**STATE SIGNIFICANT DEVELOPMENT:
Section 96(2) Modification**

***Sydney International Convention, Exhibition
and Entertainment Precinct (SICEEP), North
West Plot, Darling Square (formally The
Haymarket), Darling Harbour***

SSD 6013 MOD1

Secretary's Environmental Assessment Report
Section 96(2) of the
Environmental Planning and Assessment Act 1979

Figure 4: Comparison of the amendments to the ground floor layout (Source: Applicant's modification documents and Response to Submissions)

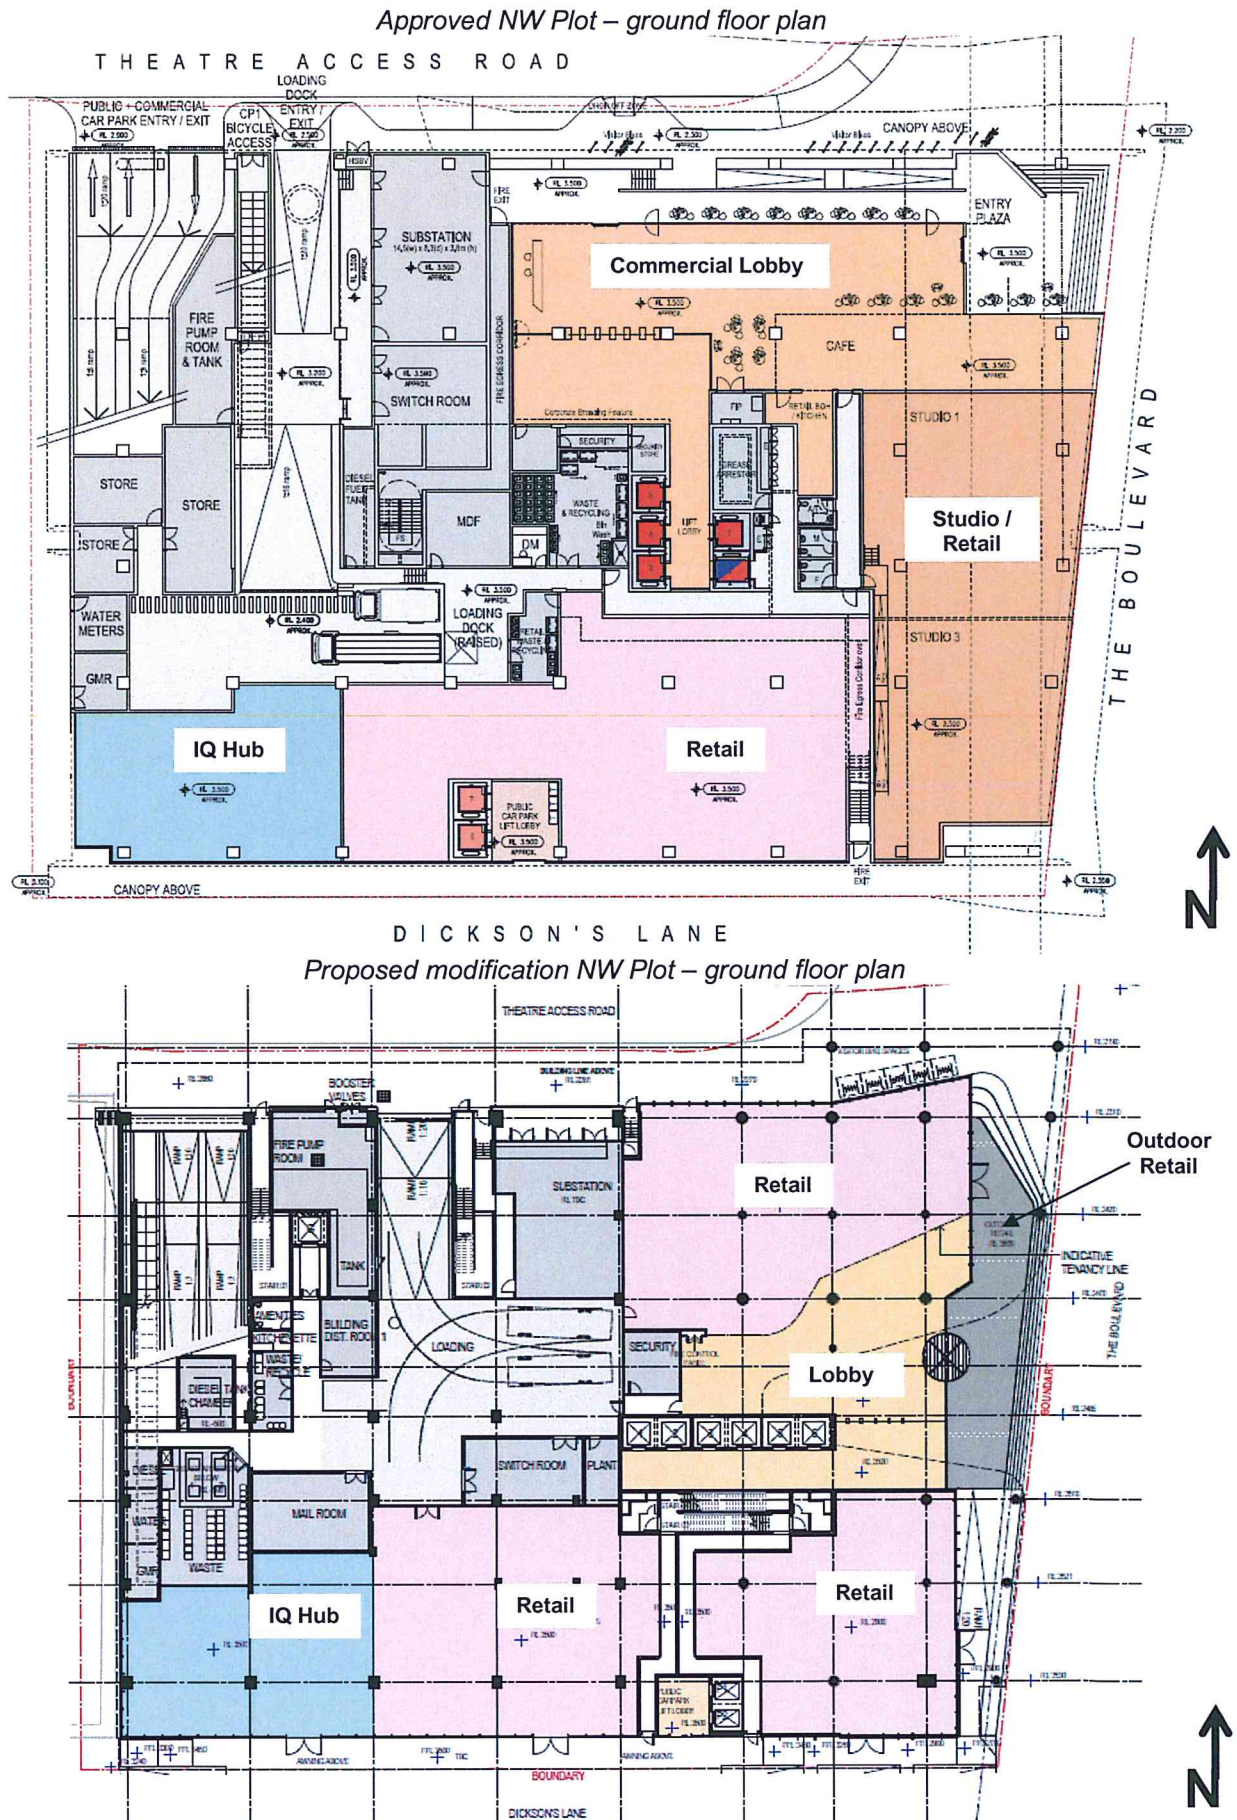
The proposal seeks to relocate the main entrance of the building from the north east corner to the eastern façade (**Figures 3 and 4**). The ground floor retail unit on the eastern façade has therefore moved to the north east corner of the building to accommodate the relocated entrance lobby.

Council raised concerns that the relocation of the entrance removes access to the building from the north eastern corner, significantly reducing activation of the northern façade at ground level. Council also raised concerns about the amount of the northern façade taken up by back of house services and requested that the ground floor layout be amended to increase activation of the northern façade by redistributing some of the services and inactive functions.

In response, the applicant has amended the ground floor layout by extending the retail unit on the north east corner to increase activation along the northern façade, as shown in blue on **Figure 7**. The proposal has also been amended so that the stairs up to the ground level entrance wrap around the north east corner, as shown in green on **Figure 7**. The applicant notes that the amendments to the north east corner and some internal reconfiguration of the ground floor layout increase the active uses on the ground floor by 359m².

Notwithstanding the amendments Council remains concerned about the lack of a building entrance on the northern façade and the overall extent of active frontages on the ground floor of the northern elevation. Noting this concern and the applicant's response, the Department supports the proposal as:

Figure 5: East-west section of the proposed building providing a comparison of the Stage 1 Concept Approval (outline shown in red) and the 2m encroachment (shown in blue) (Source: Applicant's modification request documents)

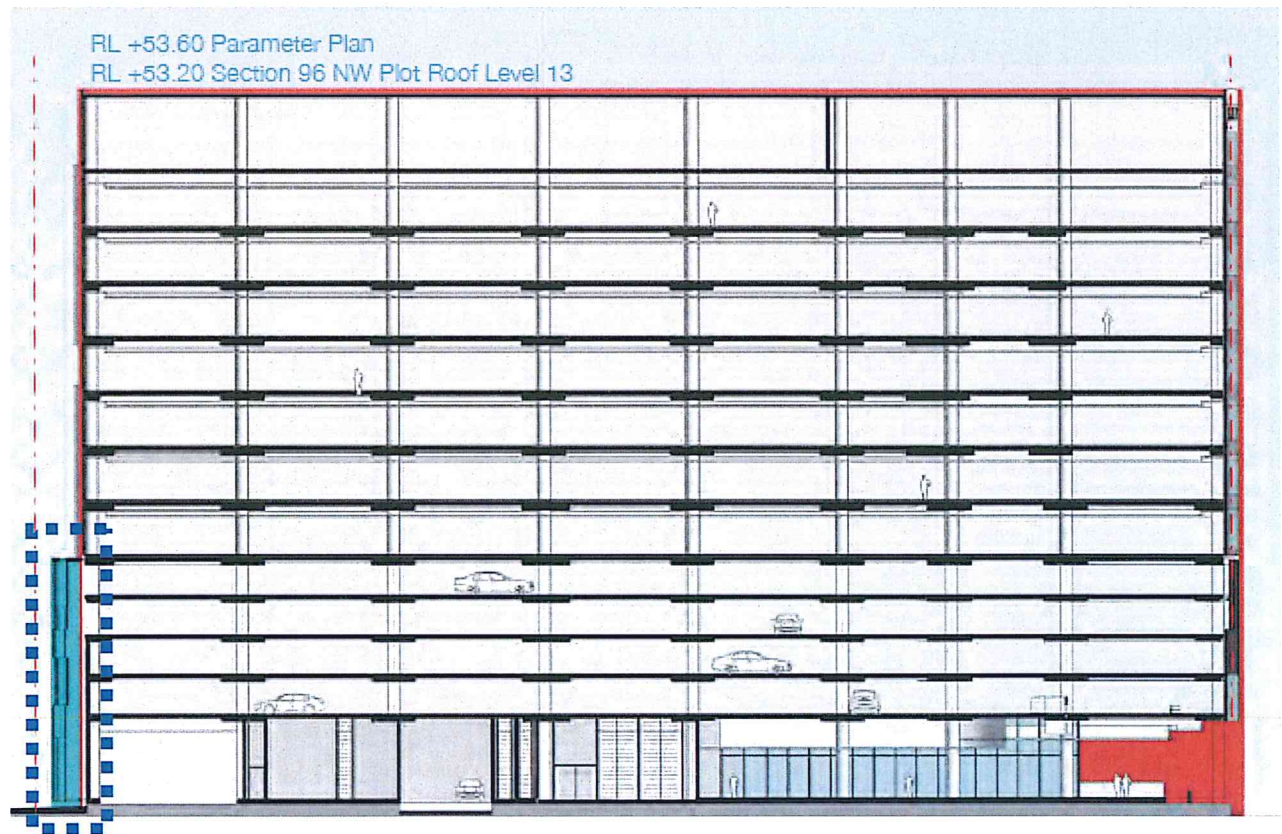
The height and scale of the approved building on the North West Plot is substantially smaller than allowed by the Stage 1 Concept Approval. Although being 2.35 metres higher than the approved building, the proposed building continues to generally comply with the requirements of the Stage 1 Concept Approval, with the exception of the following minor encroachments discussed below:

- 500mm projections on the southern, northern and western façades; and
- two metre projection at the lower four levels on the western façade.

Further, as the encroachment relates to a discreet element of the building, the Department is satisfied that the proposal remains generally consistent with the Stage 1 Concept Approval.

Figure 6: Two metre encroachment on western façade aligning with the South West Plot (Source: Applicant's modification request documents)

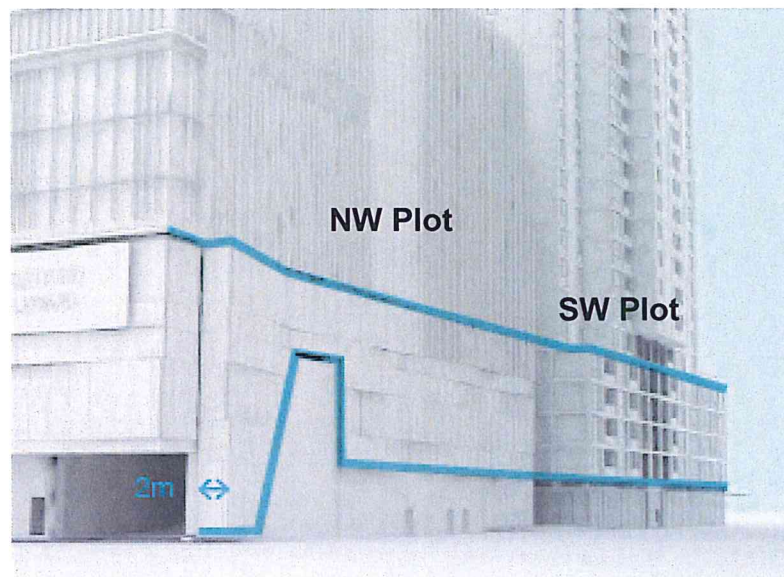
The applicant contends that the proposed two metre projection on the western façade on Darling Drive (identified in green in **Figure 5**) is necessary to accommodate a structural column and cladding to support the carpark levels, while avoiding interference with the existing subterranean service culverts. In response to this constraint the applicant has designed the structural support as an architectural feature of the building, providing additional articulation and visual interest. Further, the car park cladding is articulated to align with the podium of the approved mixed use building on the South West Plot (**Figure 6**).

The design of the encroachment as an architectural feature and relationship to the South West Plot provides a considered response to the constraints of the subterranean culvert in this location. While this encroachment will add some bulk to the western façade, this corner of the building is not highly accessible given its location adjacent to the Pier Street overpass and theatre access road. The Department considers that the proposed encroachment is acceptable because:

- the extent of the encroachment is minor in the context of the scale of the proposed building;
- it is necessary for the functioning of the building;

- it is well integrated in its design; and
- it is consistent with the approved building on the adjacent South West Plot.

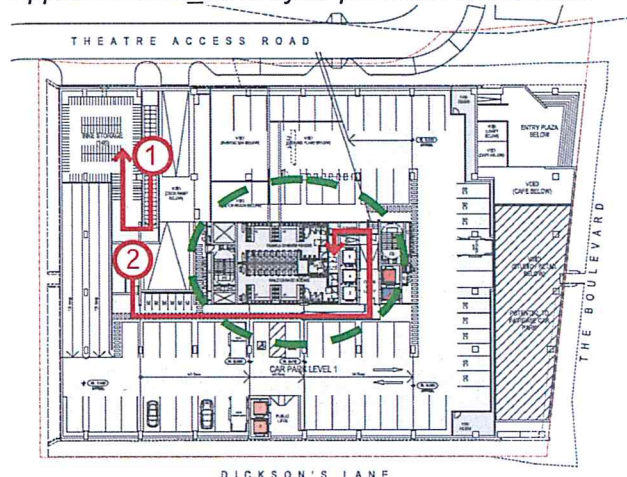
Council has questioned the suitability of the proposed outdoor retail space adjacent to the north-east retail tenancy and building lobby (**Figure 7**) as this area is likely to have high pedestrian traffic being adjacent to the main entrance / exit to the building. Council requested further information about the type and extent of the proposed activities in this location.

The applicant has confirmed that this space may potentially be used for outdoor dining depending on the tenancy of the adjacent retail unit.

The Department notes that outdoor seating is not proposed as part of this application. Any outdoor seating would be considered as part of a future application to the Council for the use of the retail tenancy. In any case, the Department considers that outdoor dining in this area may positively activate this space and the building at ground floor level under the building canopy. Active use of this space will also contribute positively to the nature of The Boulevard. However, there may be a risk that, if not carefully designed and managed, outdoor dining and in particular retail in this space could disrupt pedestrian movement entering and exiting the building. The Department supports the use of this space for outdoor dining in principle and recommends a condition ensuring that any future seating is related to the use of the retail tenancy, limited to the area to the north of building entrance only and ensures safe and equitable access to the building.

Figure 8: Reconfiguration of the cycle provision and access to end of trip facilities (Source: Applicant's modification documents)

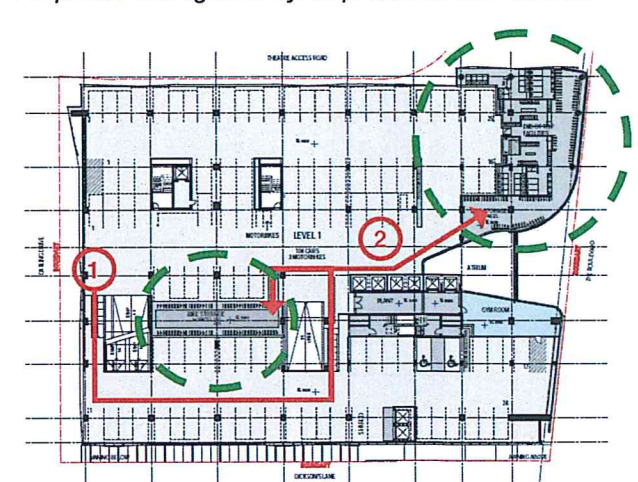
The modification proposes to increase internal bicycle parking from 146 to 160 spaces, relocate the bicycle entrance / exit and relocate the bicycle parking / end of trip facilities (**Figure 8**). No change is proposed to the 32 visitor cycling parking spaces.

The Department considers that relocating the bicycle access from in between the car park access and loading bay to the north west corner of the building will improve safety and convenience for cyclists.

The Department supports the relocation of the end of trip cycling facilities to be visible on the eastern façade, as this provides an activated and interesting feature on this façade. However, there is a risk that, if not well designed and maintained, these facilities may negatively impact on the appearance of the building on this prominent façade (**Figure 9**) that is highly visible from the Boulevard. The Department therefore recommends a condition that future fit out of this space must include specific details setting out how this space is designed and how it will be used and maintained to ensure the high quality appearance of the building.

Figure 10: South east corner of the building (Source: Applicant's Response to Submissions)

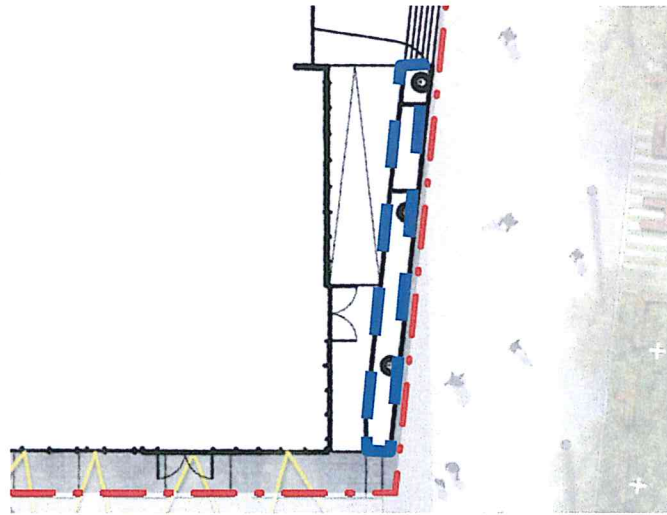
Council requested additional information on the proposed treatment of the area in between the external columns at the south eastern corner of the building (**Figure 10**). Council's submission states that this could provide an opportunity for landscaping or a high quality finish to reflect the location of this corner on the building's principal frontage.

The applicant confirms that this structural element is proposed to be finished in the same material as the entry stairs, being polished off-form concrete, to be coordinated with the finish of the building, and given its height it could be used for seating.

The Department considers that the applicant's treatment of this space is appropriate.
